# EAST LODGE, DYRHAM PARK – PROPOSED MASONRY REPAIRS TO SCREEN WALL

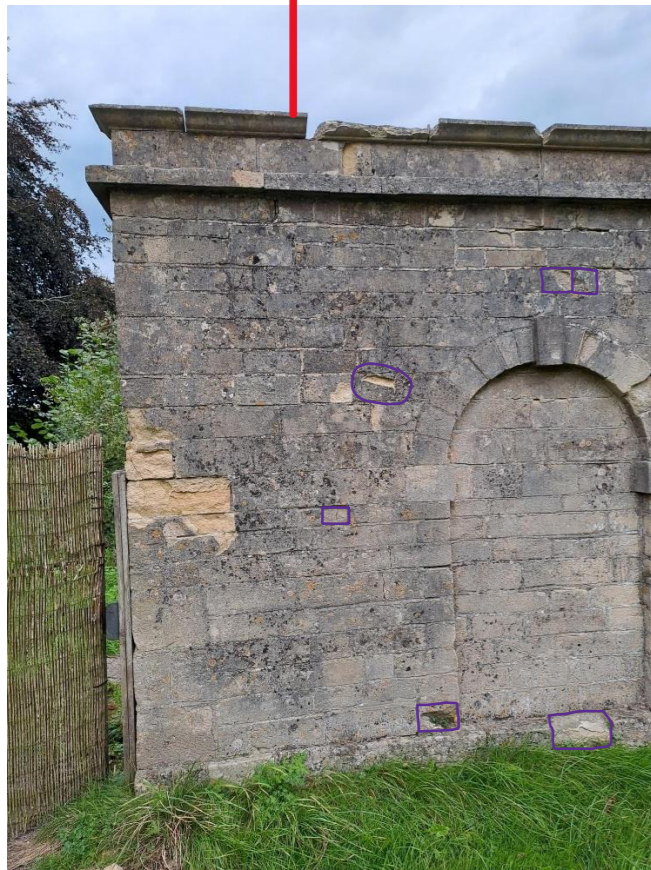
8 no. damaged Bath Stone coping stones to be renewed at top of wall and mortar repairs to upper surface of 2 no. to prevent water ponding.

All coping stones to be repointed in lime mortar

Piecing in to damaged Bath Stone quoins

Piecing in to damaged Bath Stone parapet stone

Mortar repairs to upper face of lower copings to prevent water ponding

New Bath Stone to be pieced into voussoir and repointed in lime mortar

Piecing in new Bath Stone to replace 15 no. damaged facing stones (purple squares shown on pg 1 above) and 8 no. lime mortar repairs (purple circles shown on pg 1 above) across face of wall to prevent water ponding.

Selective repointing in lime mortar where missing/loose especially at base of wall

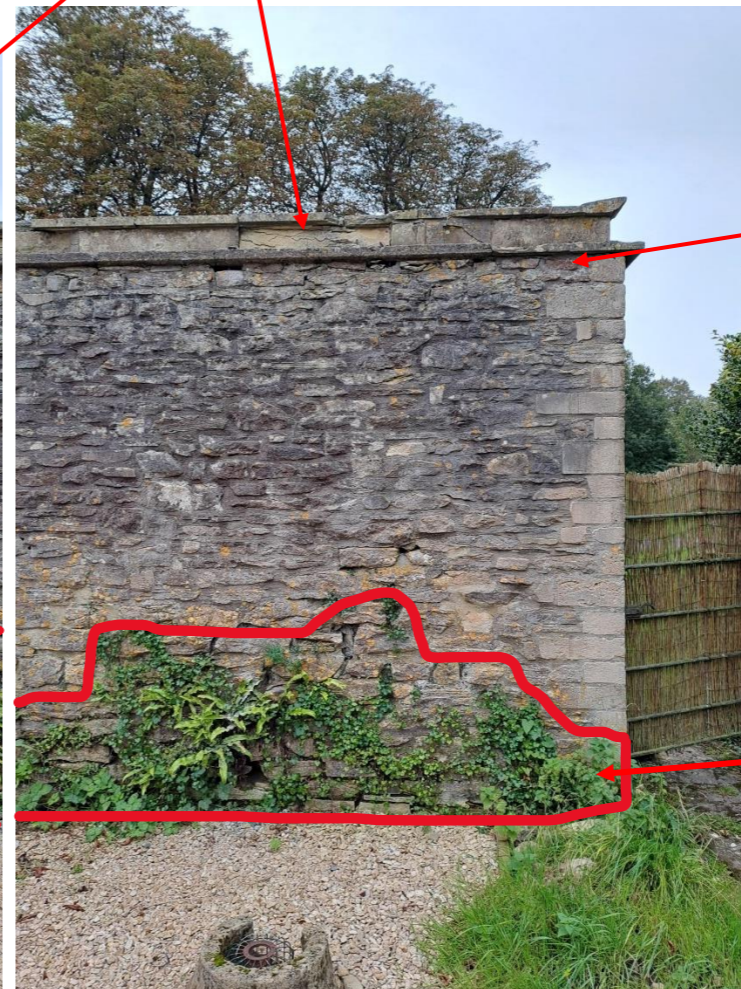
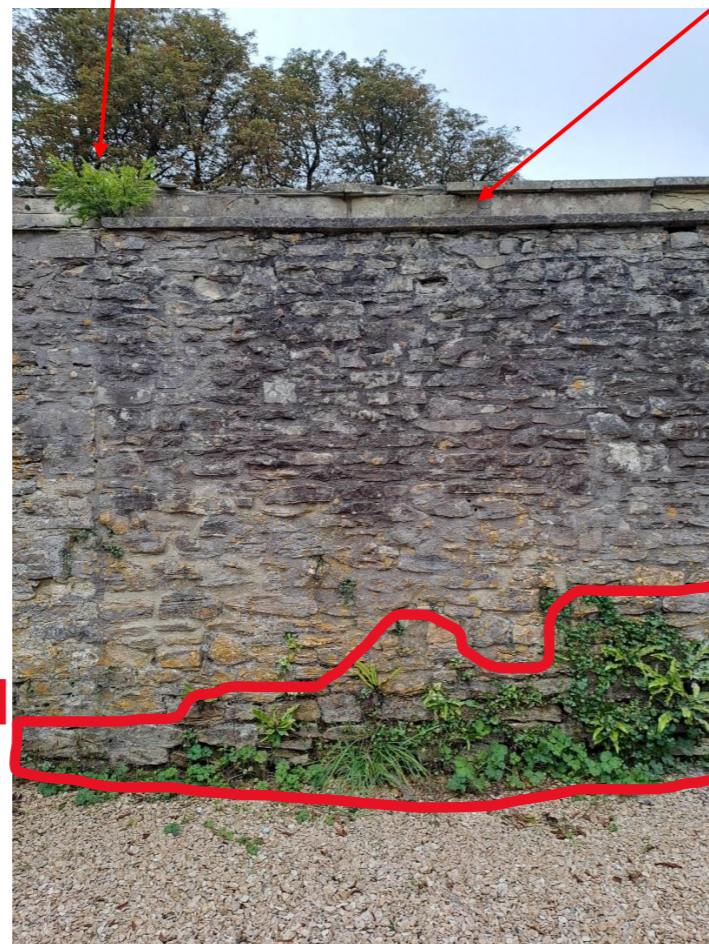
Damaged render to parapet stones to be renewed in 2-coat lime render

Tree sapling growing in wall head to be removed

Damaged Bath Stone parapet stones to be renewed

Lower coping bed joints to be repointed in lime mortar

Vegetation in wall to be removed and wall repointed in lime mortar where mortar missing or loose

Small section of damaged Bath Stone coping below lead to be renewed

Masonry below lead weathering to be repointed in lime mortar where existing pointing loose/missing

Hollow and cracked render to be removed and renewed in 2-coat lime render

Lower Bath Stone coping edges to be cut back and renewed
